PLANNING APPLICATION PLN-19-0071

81 EVANDALE ROAD, WESTERN JUNCTION

.....WESTERN JUNCTION QUARRY EXTENSION.....

**DEVELOPMENT PROPOSAL AND
ENVIRONMENTAL MANAGEMENT
PLAN**

Figure 2.9 –Geology Missing from DPEMP

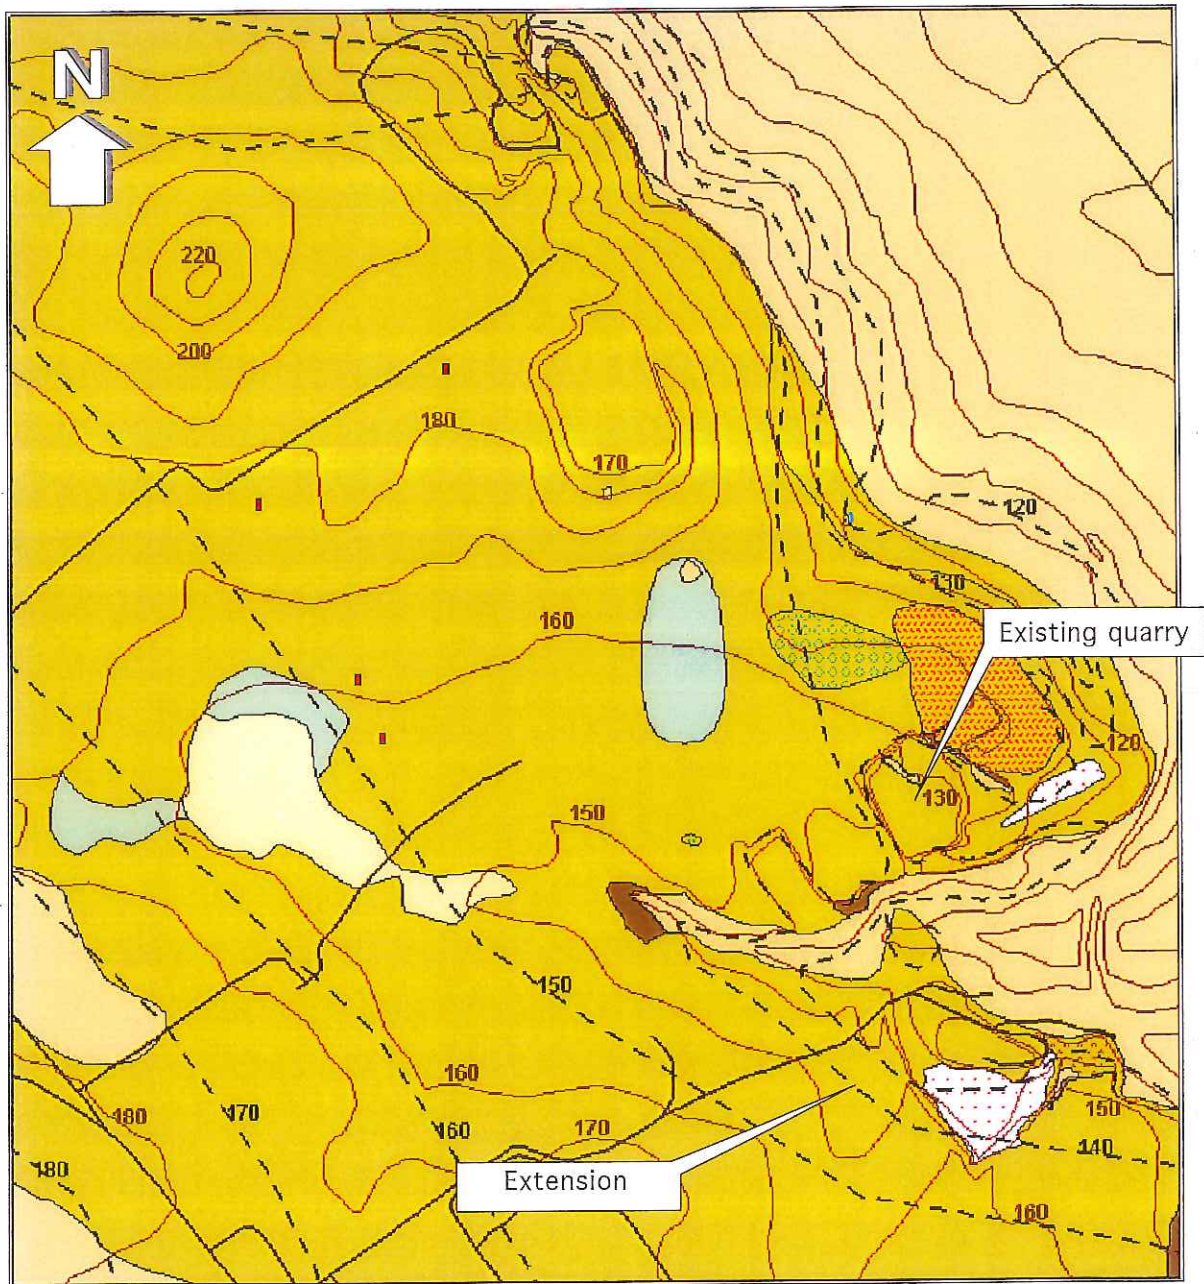
This is largely based on the MRT report referenced in the DPEMP. Inadvertently, Figure 2.9 which is the MRT Geology Map was missing in the DPEMP (and also not noticed by MRT !) and as stated, was used in the resource assessment. This Figure is attached in **Appendix B**.

D Hughes Western junction Quarry
 1km Radius Lines around ML's

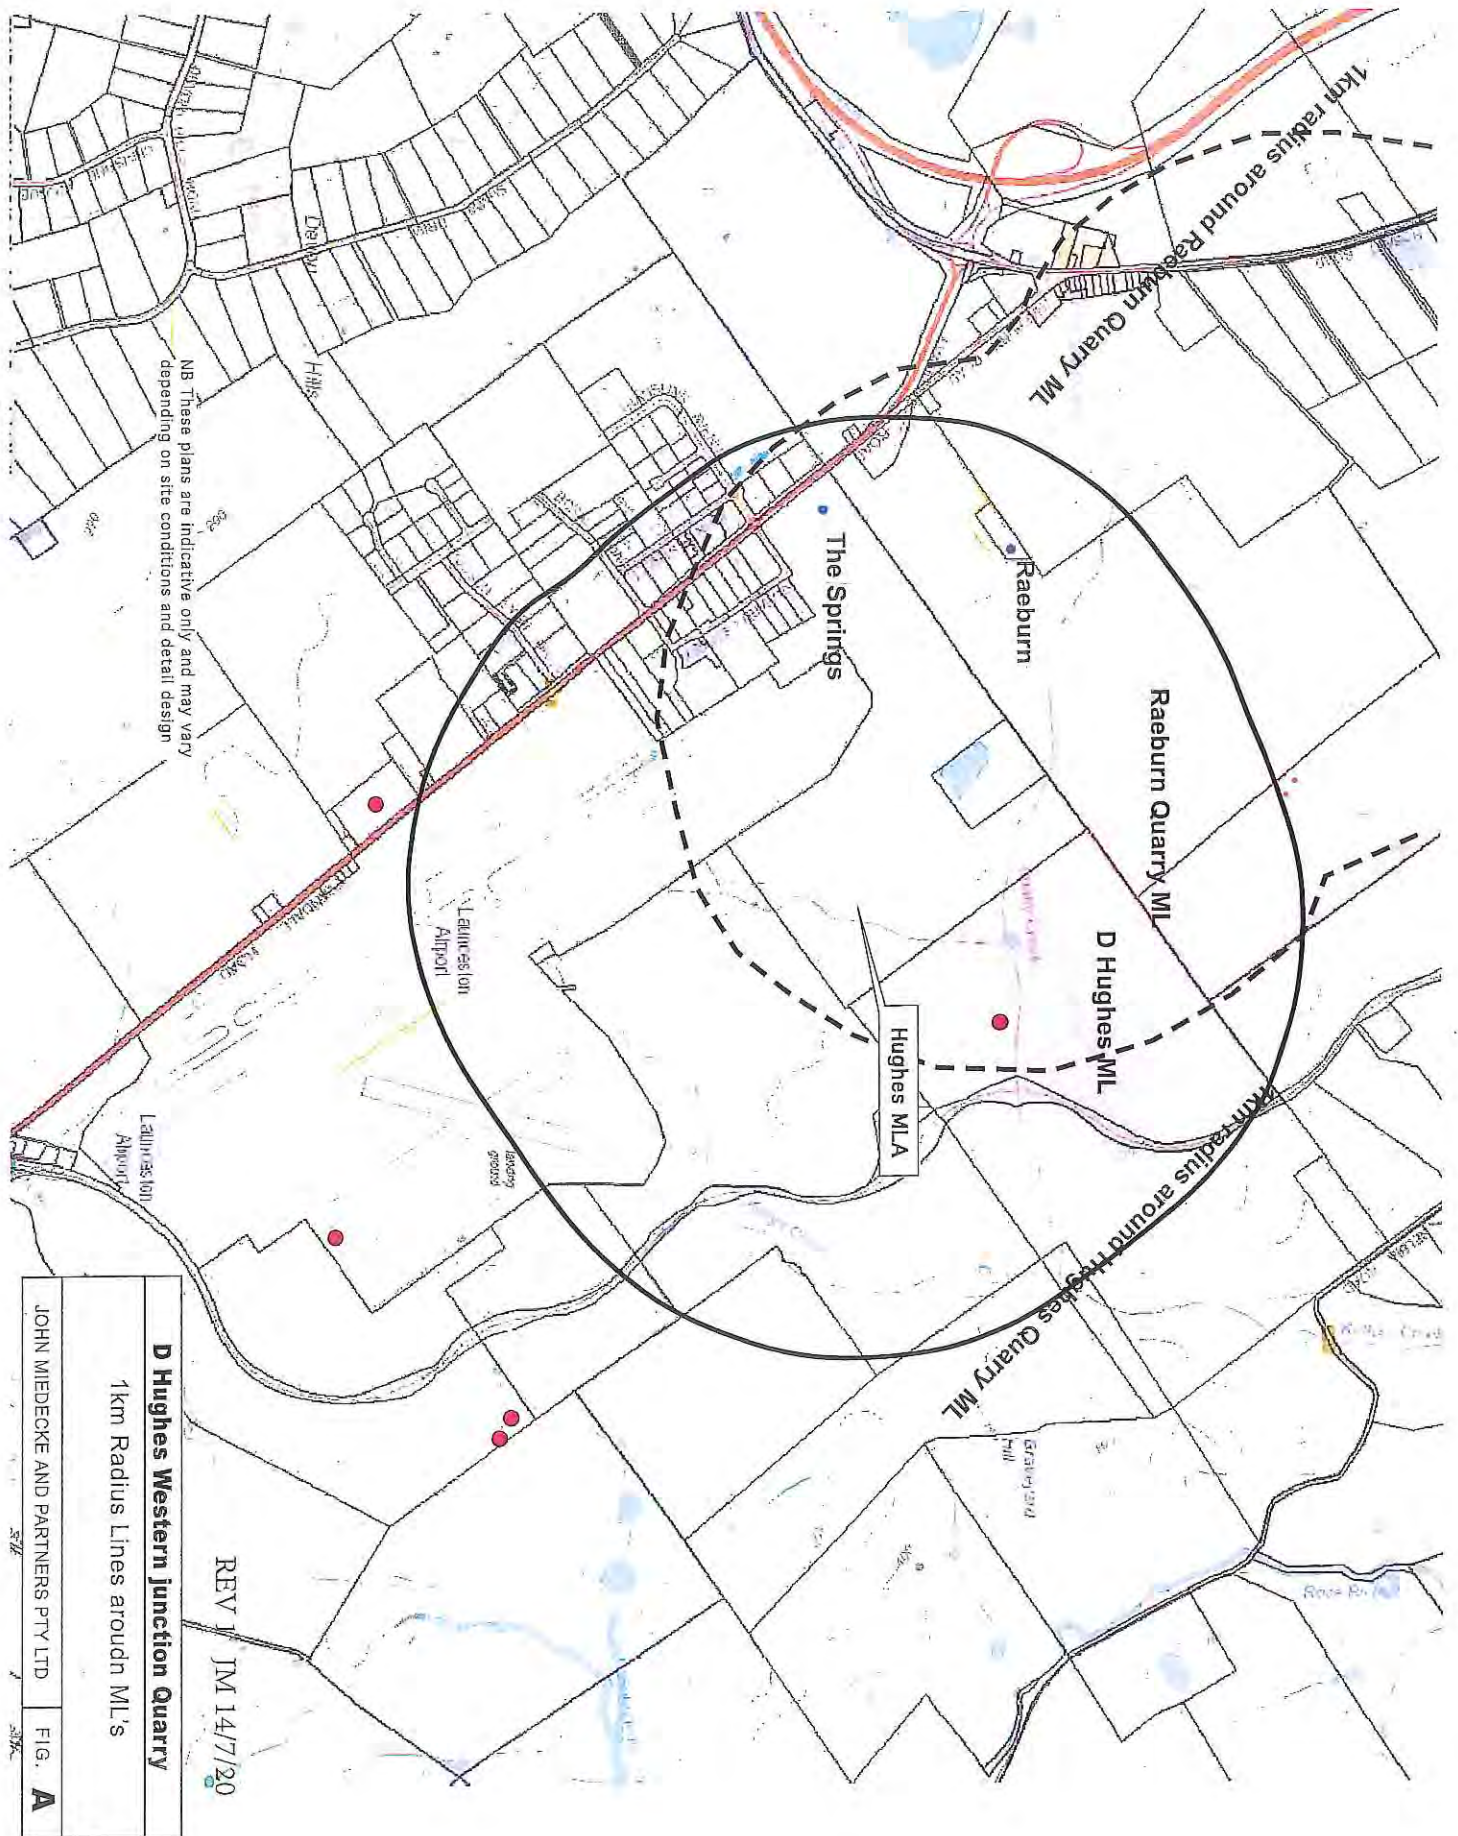
SRADS or Standard Recommended Attenuation Distances are included in the planning scheme as Table E11.1. These are used by the Council to replace the previous schemes "buffer zone" mapping. They are used by Councils as a guide to review approvals for "sensitive uses", e.g houses, in proximity to an existing activity, or proposed new activity as stated. It is correct to say that the SRAD of 1000m

should be drawn around the ML boundary. However, Figure 3.2 showed Zoning and did not represent SRADs around the ML area.

Figure 3: Cross Section

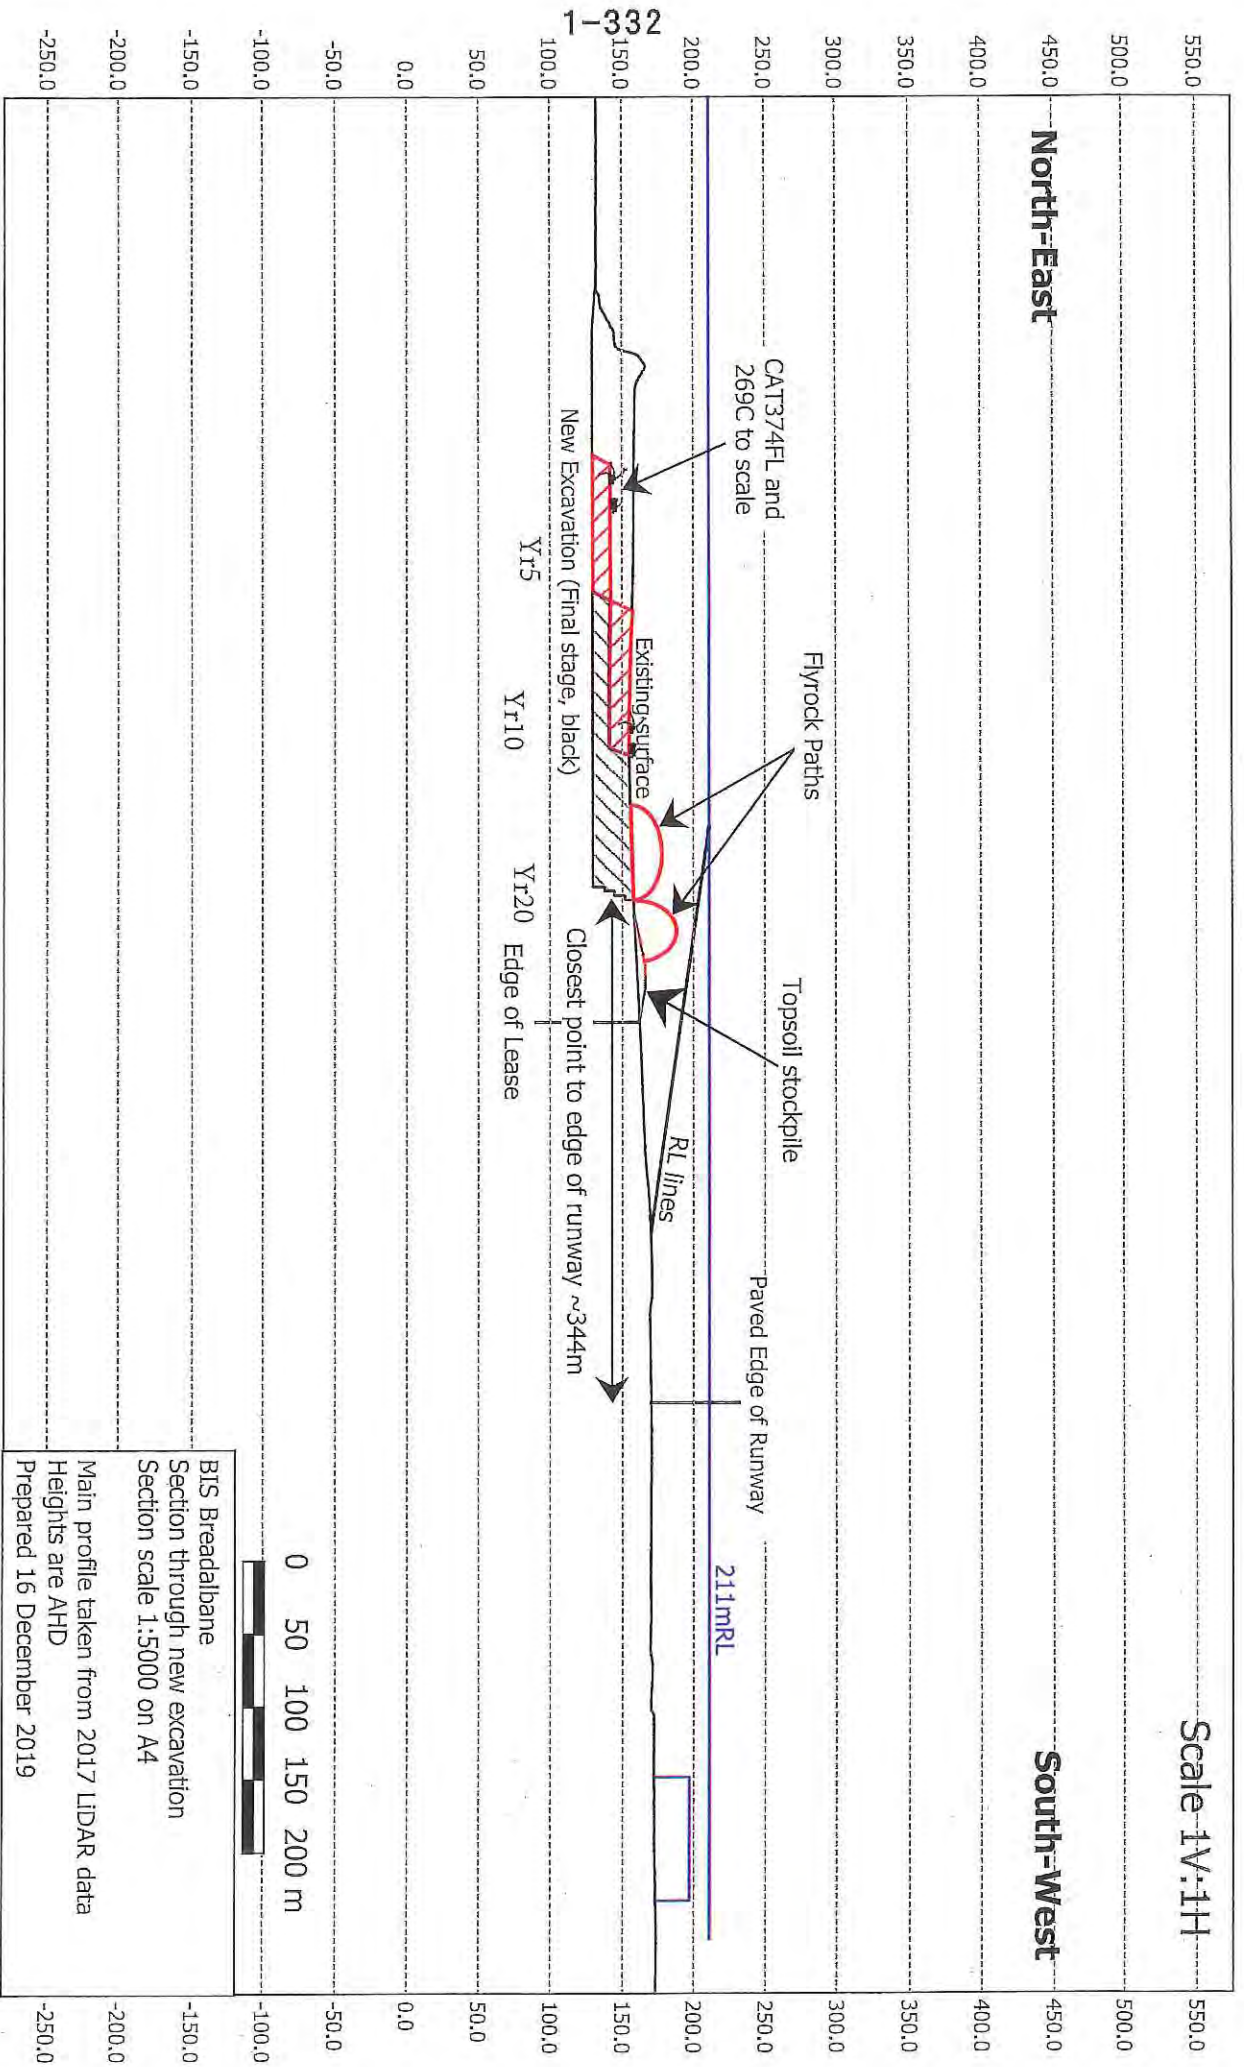
It is likely that final extraction would be greater than 18 years away and therefore it is not possible to sensibly show much more than the indicated positions. As the Quarry will go through multiple EMP reviews this will be monitored at these reviews. An indicative section is shown (Fig 3) in Appendix B .
